Addendum No. 1

Project No: 22132

Project: **Proposed Mixed-Use Building 510 & 520 Taunton Rd E**
GAY COMPANY LIMITED

The following information supplements and/or supersedes the bid documents issued on September 28, 2026

SCHEDULES

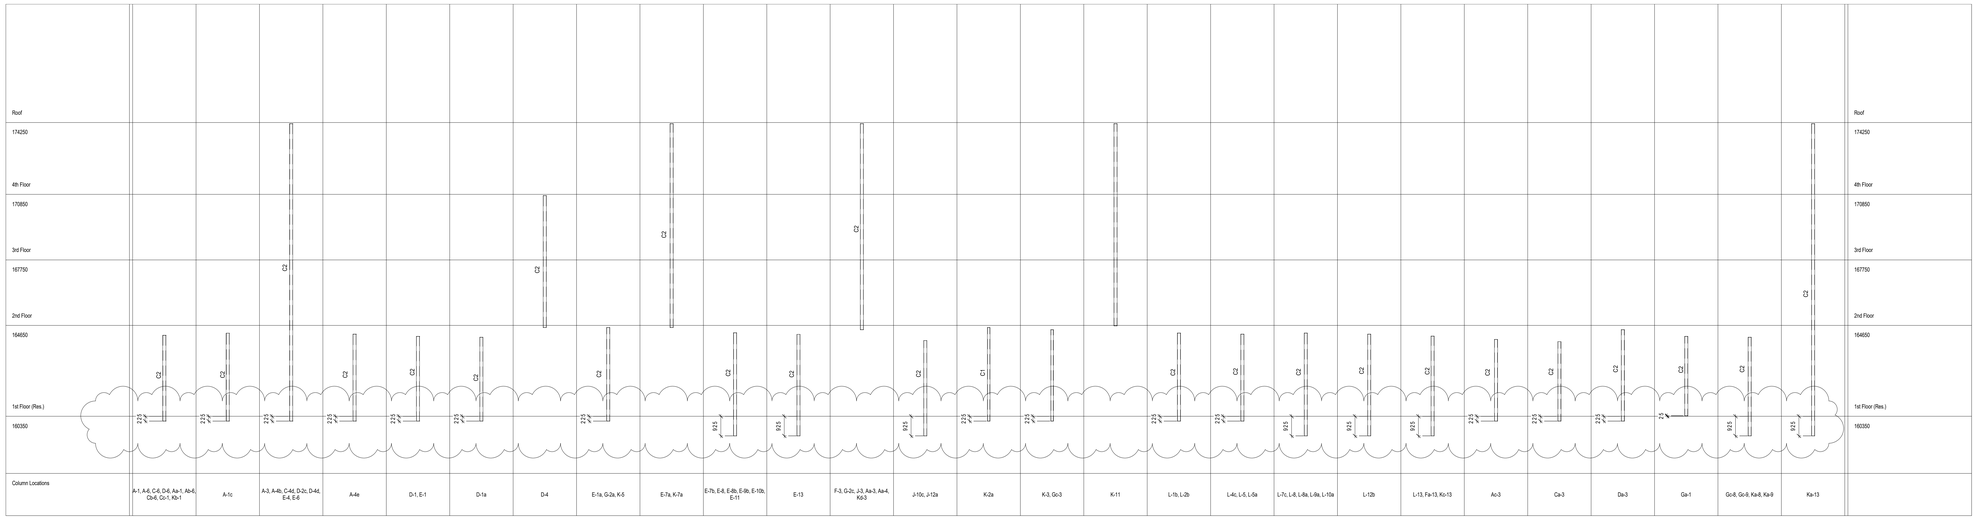
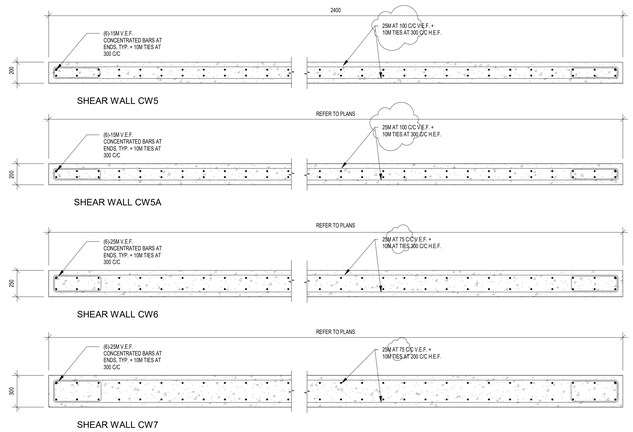
.1 Shearwall reinforcing updated. See shearwall schedule.
.2 Steel column thickness increased. See column schedule.
.3 Concrete pier reinforcing updated. See pier schedule.
.4 Elevations of bottom of columns added to column schedule.
